©Kawasaki Motors Corp 1974 Printed in USA

### PROBLEM:

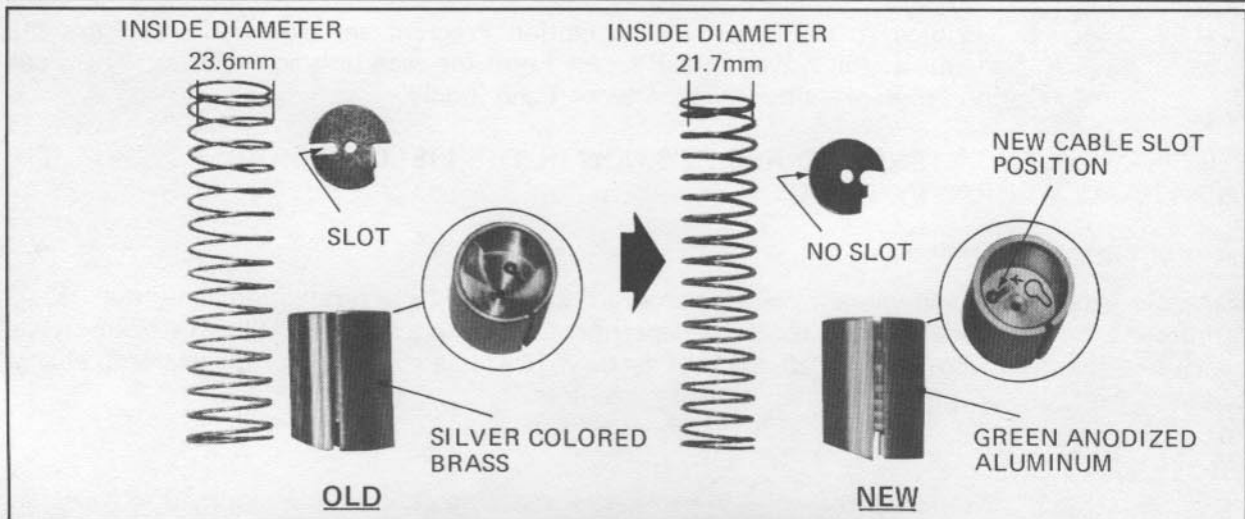
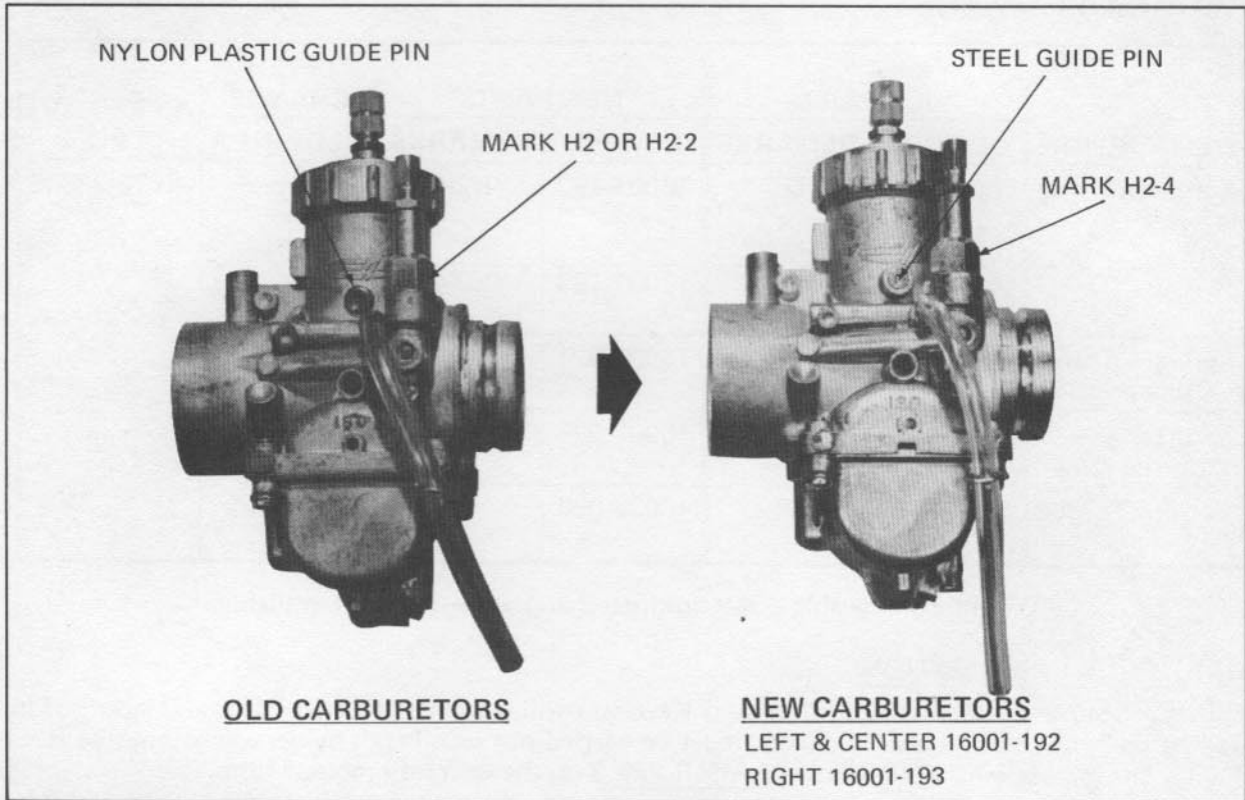
By monitoring warranty records, it has been determined that carburetor jet needle breakage is a recurring problem on many H2's. This failure results from the combination of throttle valve bore wear and engine vibration. In some cases, the broken jet needle has become lodged in the engine, causing severe damage.

To remedy the problem of jet needle breakage and reduce the possibility of engine damage, the three original carburetors must be replaced with new-type carburetors designed specifically to eliminate this problem. The new carburetors incorporate a redesigned light weight throttle valve slide, a heavier return spring, a modified spring seat, and a steel throttle valve guide pin. All other component parts remained unchanged from the "H2-2" type carburetor.

In addition to the modifications noted above, the new carburetors incorporate the following revised settings. This second change obsoletes previous changes and only the "H2-4" carburetors have been used in production since engine number H2E-23846.

CARBURETOR SETTINGS	"H2" OLD	"H2-2/H2-4" NEW
Main Jet	105R	#97.5R
Jet Needle & Clip	5FL14-2nd	5EJ15-3rd
Needle Jet/Primary Choke	#0-6/2mm	#0-6/8mm
Throttle Valve Cutaway	#2.5	#2.5
Air Screw	1-1/4 turns out	1-1/2 turns out
Pilot Jet	#35	#35
Starter Jet	#40	#70
Air Jet	0.5mmØ	0.5mmØ
Carb I.D. Mark	H2	H2-2/H2-4
